CITY OF PANAMA CITY BEACH
September 8, 2023

ADDENDUM NO. #3

**PCB23-48 ITB
FIRE STATION #32**

This addendum modifies Fire Station #32 Bid Documents dated August 1, 2023

C1.5C

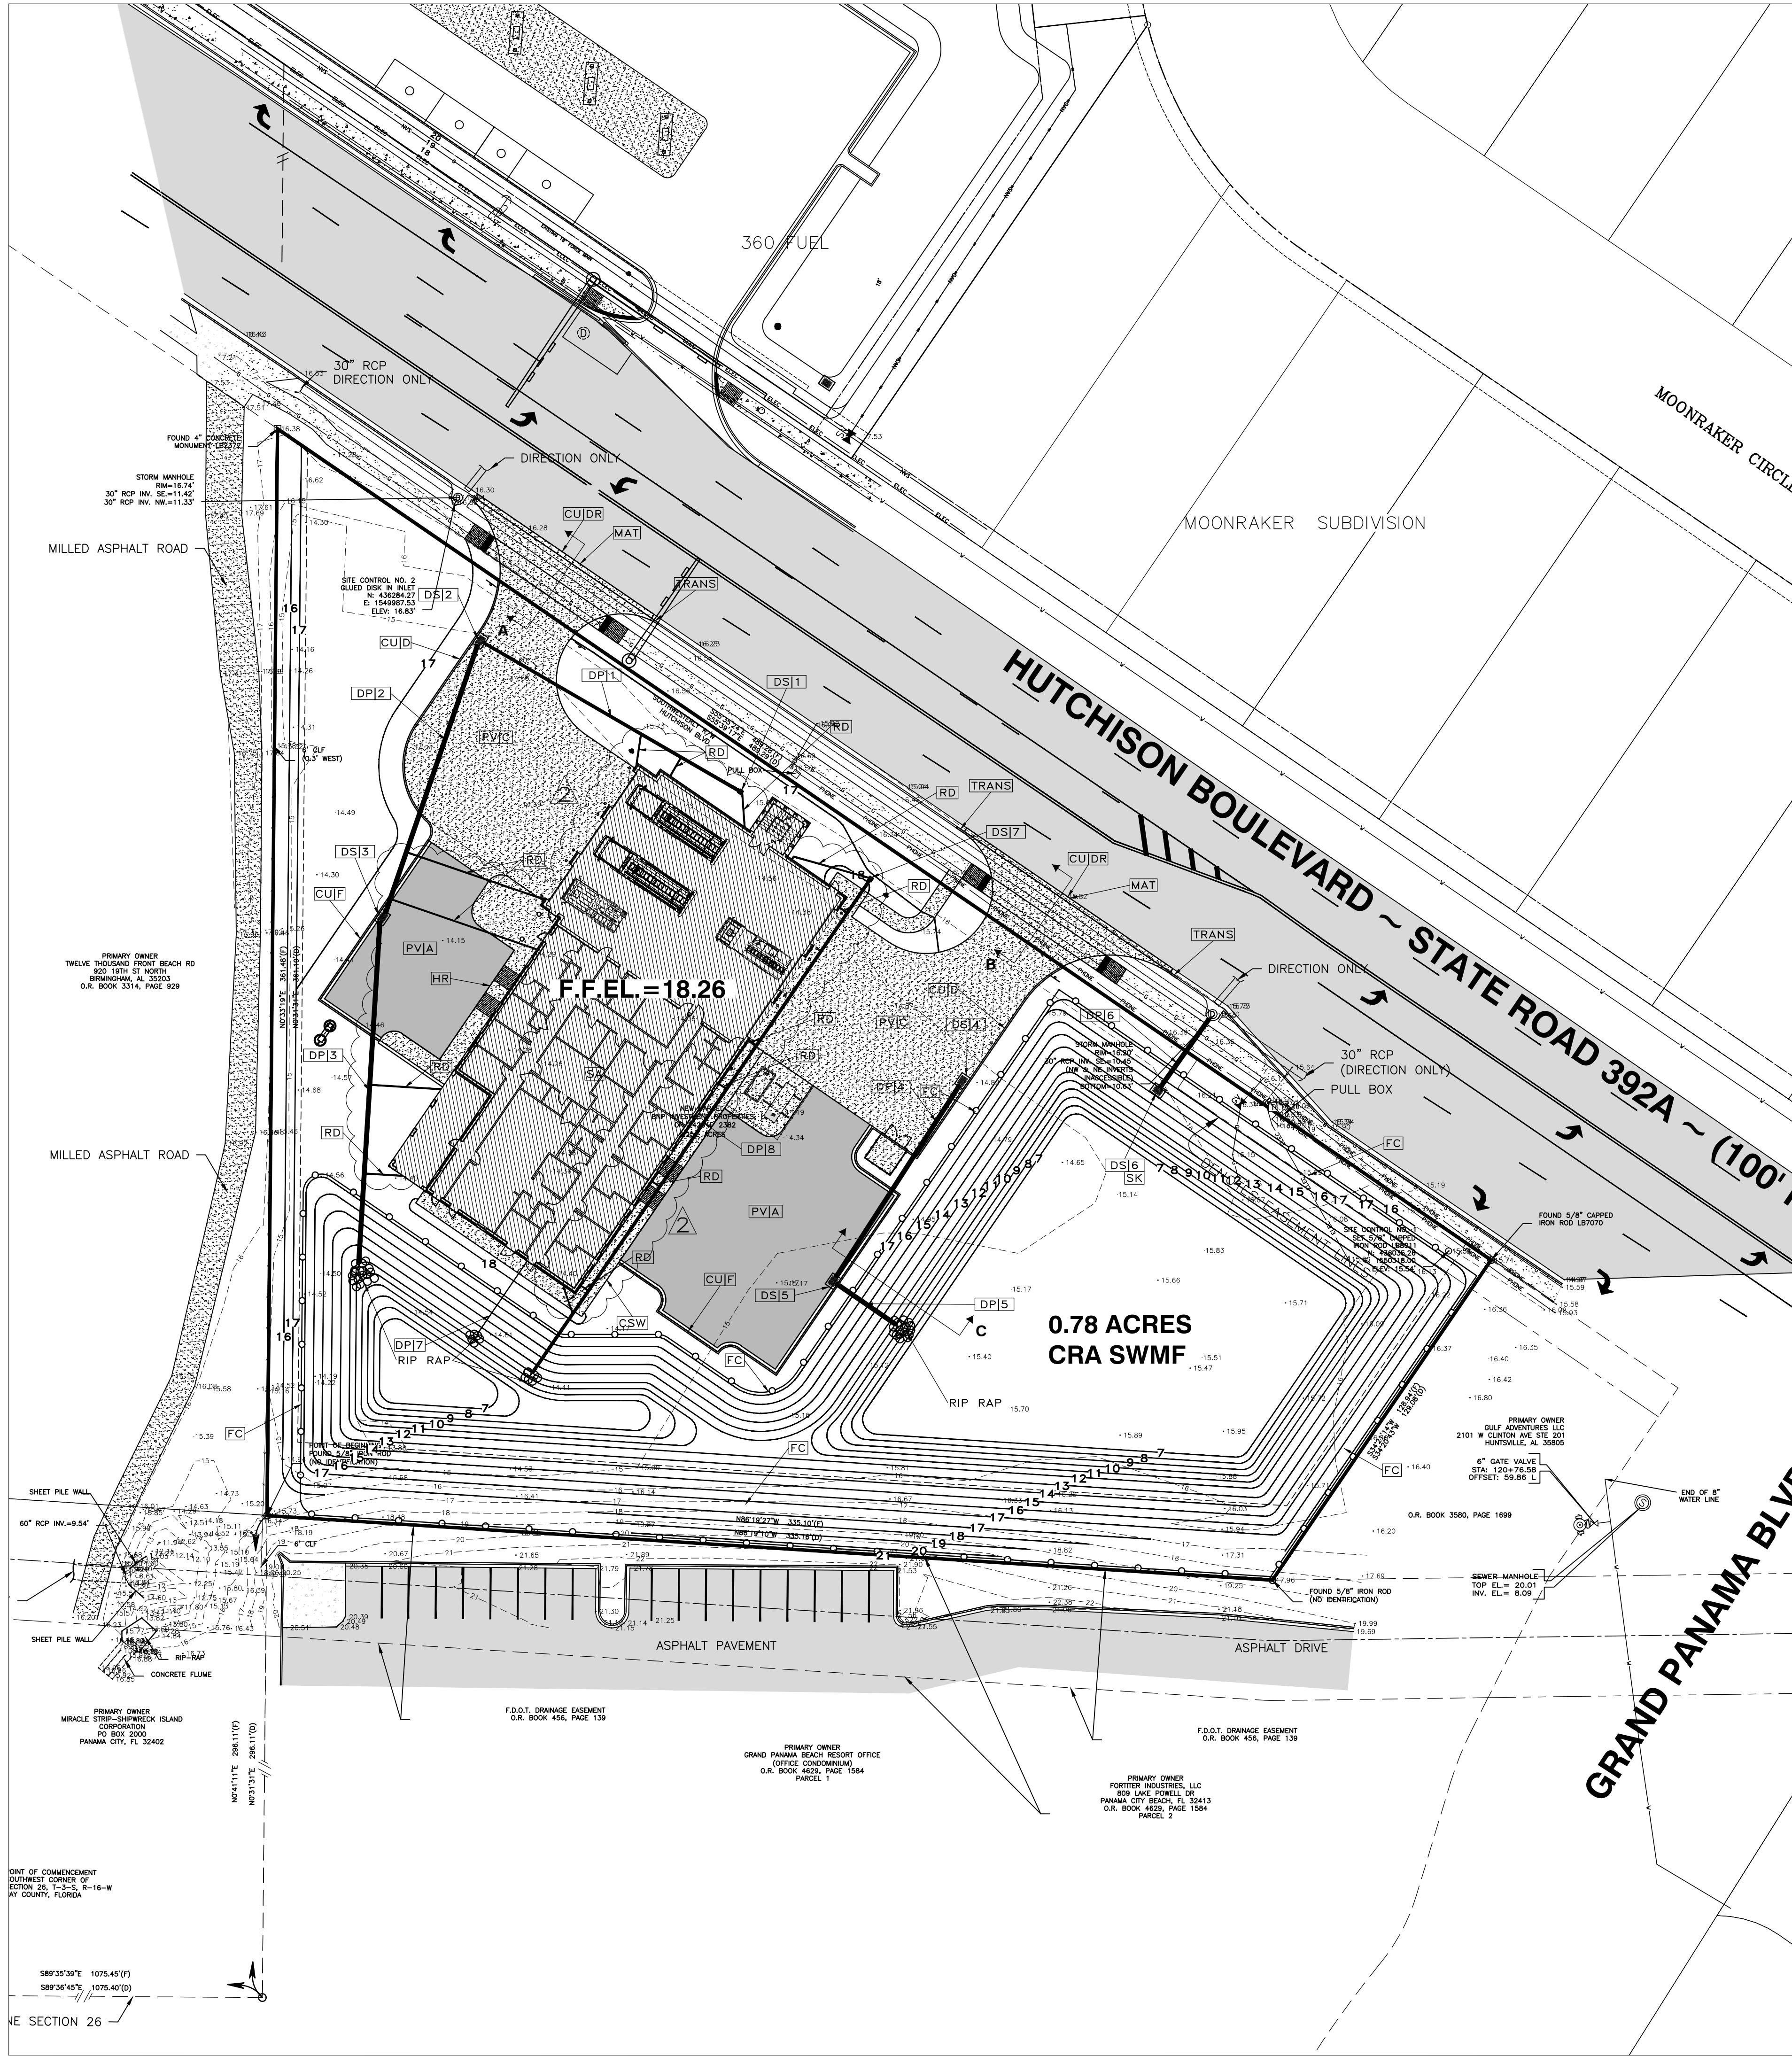
A. No high traffic areas are indicated, IR wall board is not required.
4. Sheet C1.5C shows one roof drain connection to one downspout. Sheet A1.1A shows fourteen downspout locations. Please advise.

A. Please see attached revised sheet C1.5 depicting all roof drain connections.
5. Sheet C2.7 calls for LBR 40 under the asphaltic pavement. Is LBR 40 required under the concrete pavement?

NO.	DESCRIPTION	DRAWN	CHECKED	DATE
01	UPDATED ROOF DRAIN LOCATIONS			09/08/23
